**PLANNING & ZONING COMMISSION
Regular Meeting
Wednesday, February 15, 2017
6:30 p.m.**

TO: Planning & Zoning Commission
FROM: Heather Valone, Village Planner
THUR: Jeffrey Stein, Deputy Village Administrator
SUBJECT: Case 16-10 Vistancia Annexation, Rezoning, and Preliminary PUD
DATE: Updated: February 10, 2017

VISTANCIA

Figure 2 The arrow indicates where the subdivision sign and landscaping should be moved to improve the sightlines of the proposed intersection. The Xs indicate the landscaping that should be removed.

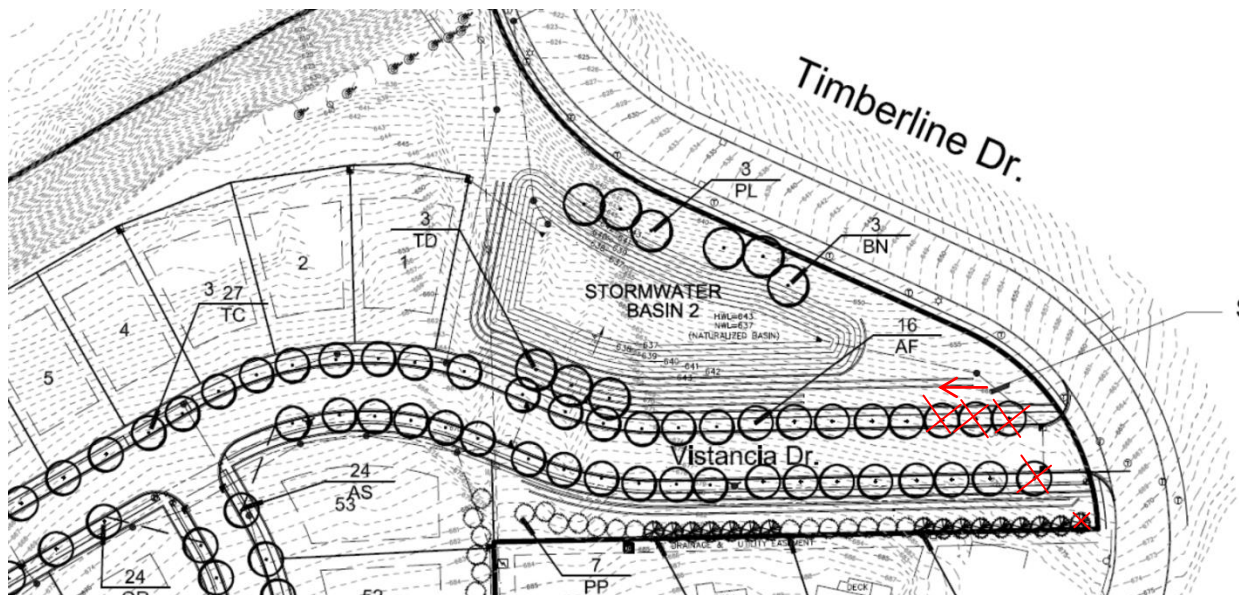
The proposed landscaping around the north side of the Timberline Dr. entrance is a concern of staff. Staff is recommending that three (3) of the parkway trees along the north side of Vistancia Dr. be removed and the landscaping for the subdivision sign be shifted west (Figure 2). One (1) parkway tree and one (1) evergreen tree are also being recommended for

removal along the south side of the Timberline Dr. entrance as well. The removal/shifting of this landscaping will improve the safety of the intersection by allowing traffic utilizing Timberline Dr. and Vistancia Dr. to more easily see vehicles approaching the proposed intersection. The applicant indicated in a memo submitted with the revised plans that the landscaping was removed per staff's recommendation. However, the plan was not updated. Thus the applicant is willing to comply with the recommendation and the plans only need to be revised.

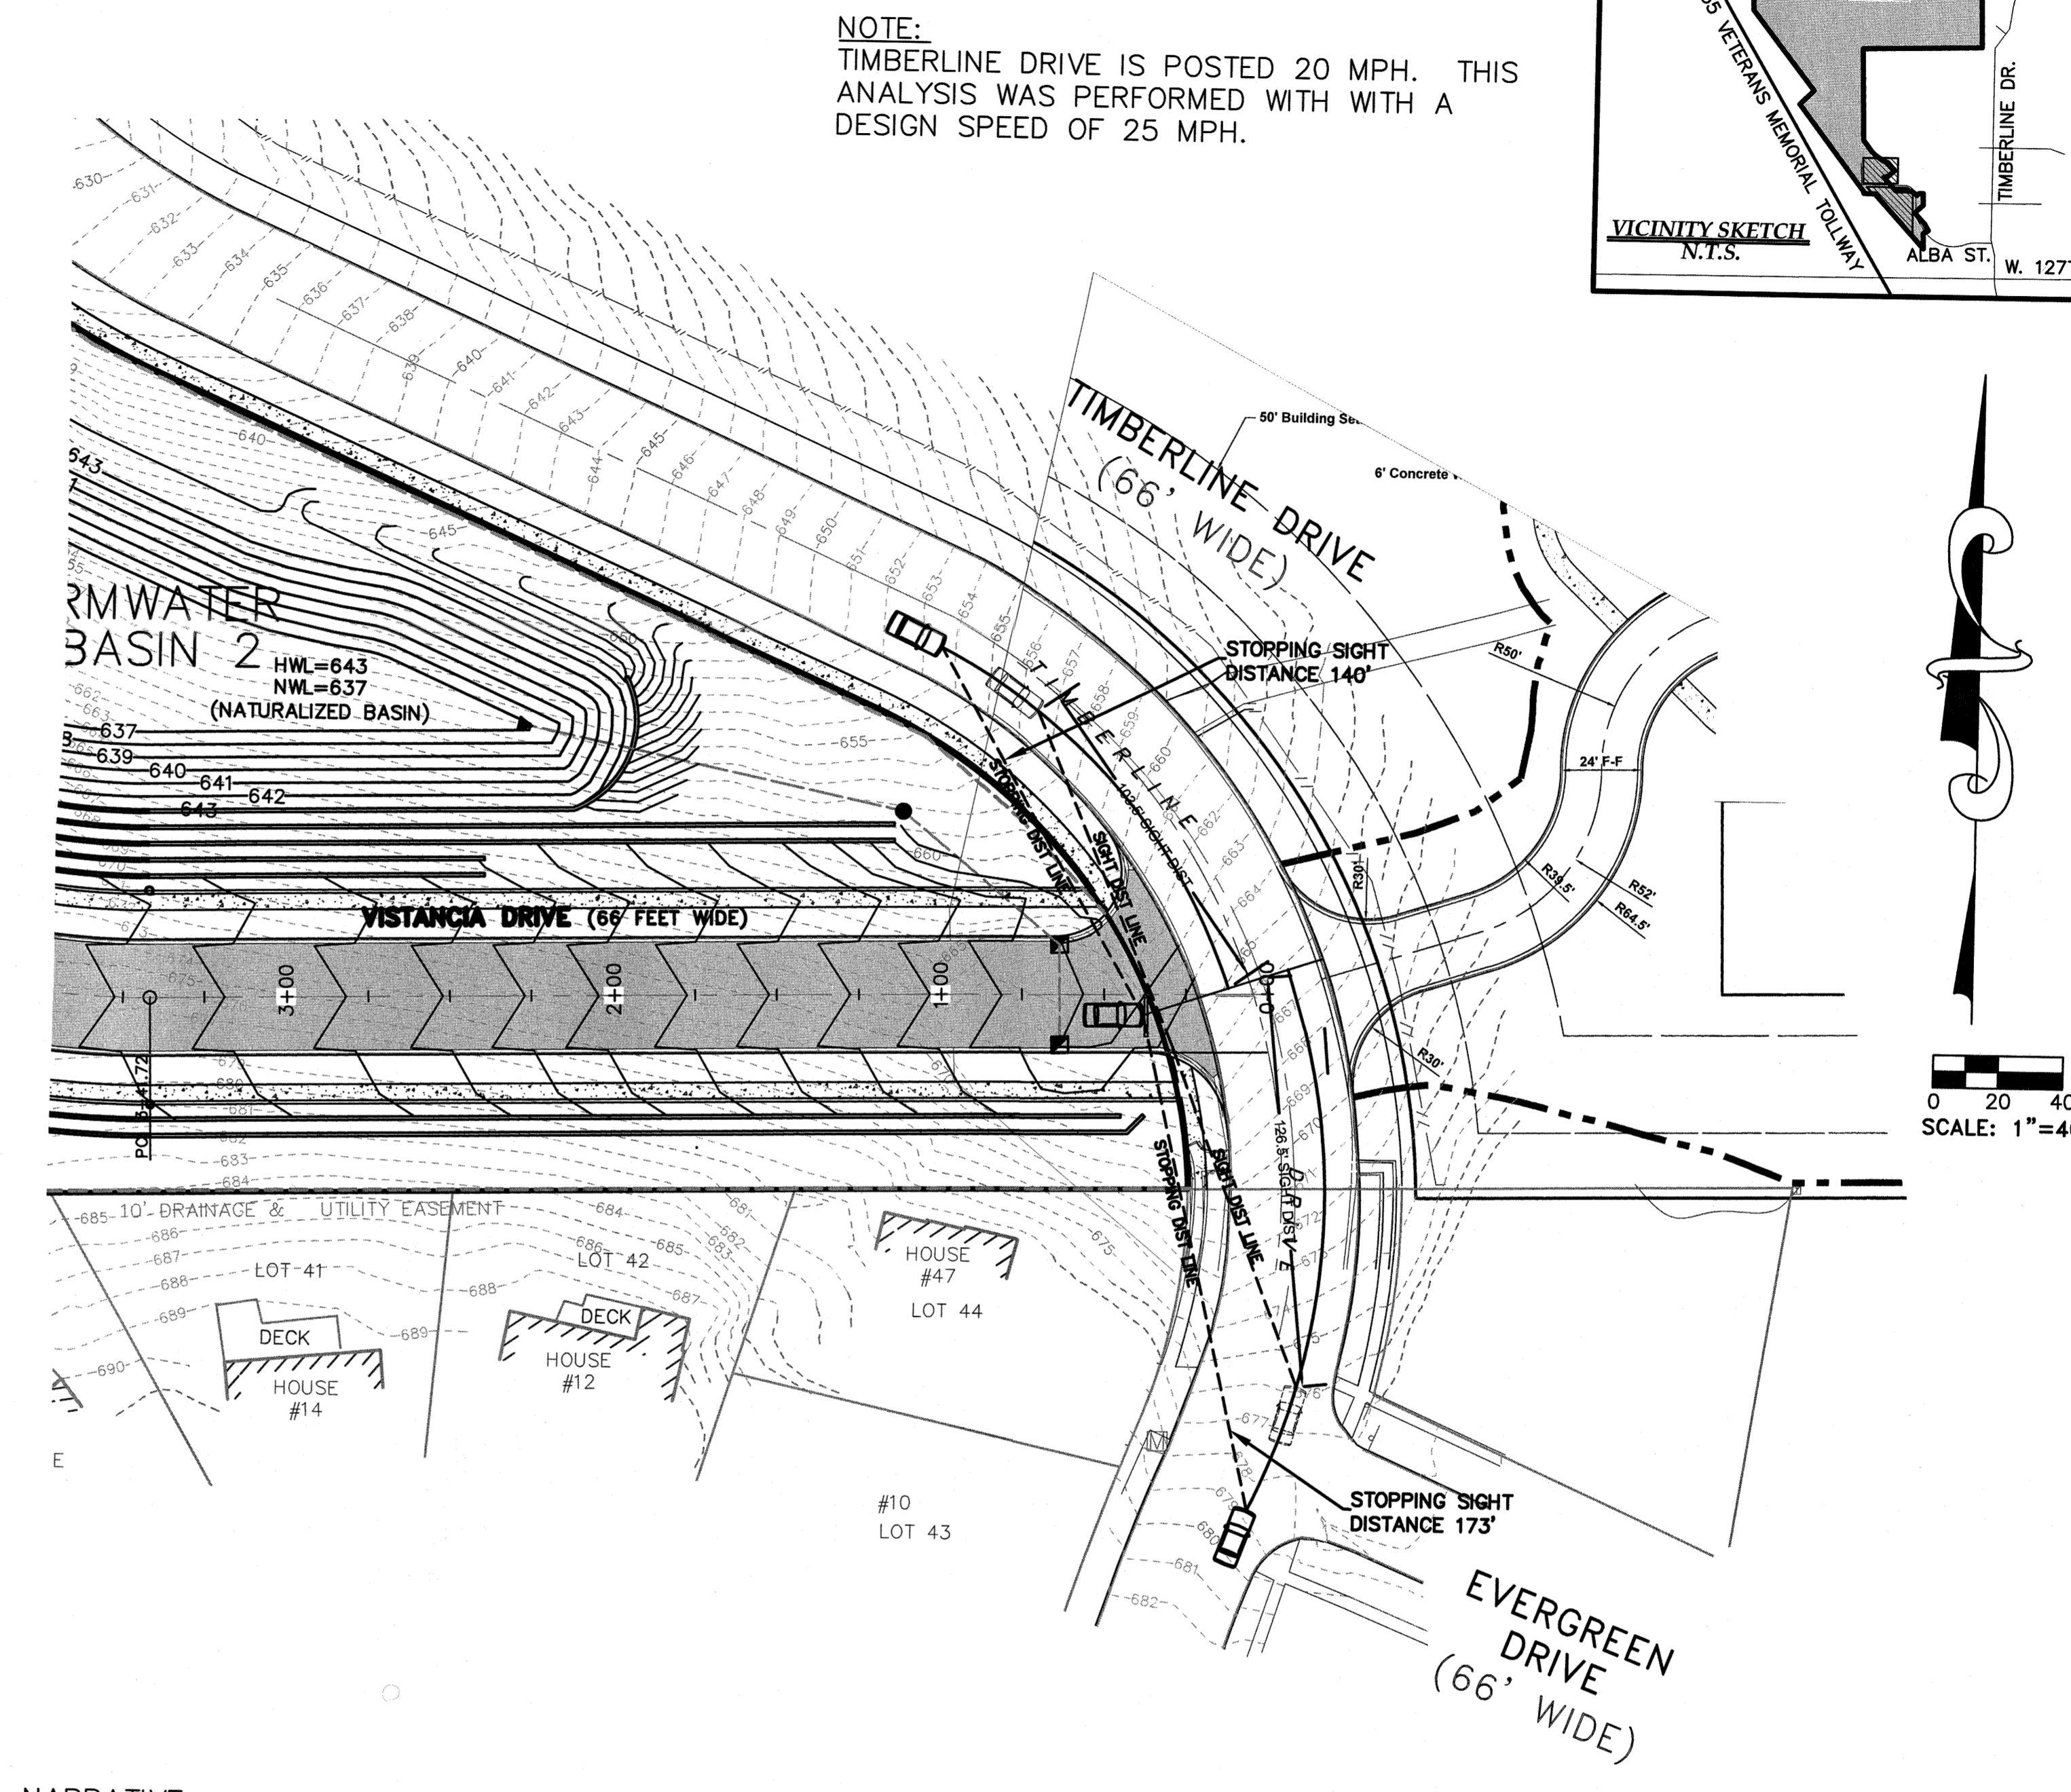
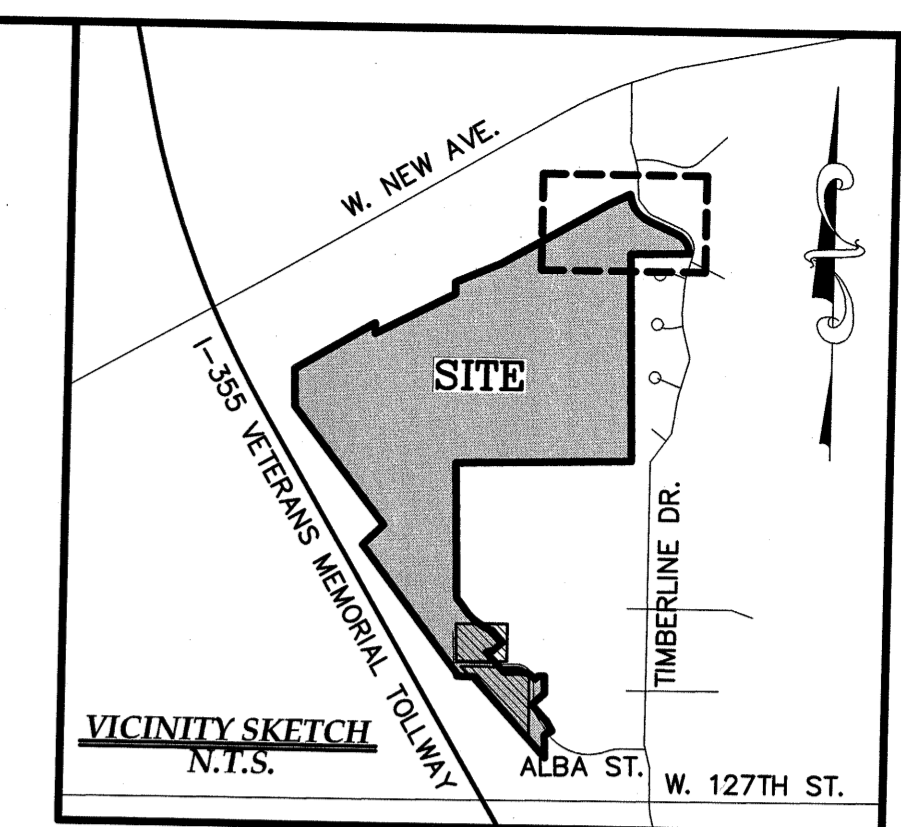
20. Sheet C-11.0 of the engineering plans shows the site line exhibit and back up calculation data for same. The site line is shown on Vistancia Drive as being taken from a location in the vehicle in front of the stop bar and crosswalk. (The stop bar is normally set 4 feet behind the crosswalk.) Due to the location of Evergreen Drive, it is my opinion that the location of Vistancia Drive and the Timberline West entrance drive are at the best location, given all the other undesirable options. The proposed site lines need to be made as "clean and clear" as possible, with removal of all trees and earth mounds that may block the view. Southbound stop controls on Timberline Drive at Evergreen Drive or Vistancia Drive could be a future consideration. Northbound stop control on Timberline Drive at Vistancia Drive would be a challenge in winter, due to the 8.3% uphill grade. Speeding vehicles on Timberline Drive will cause a problem, in any case.
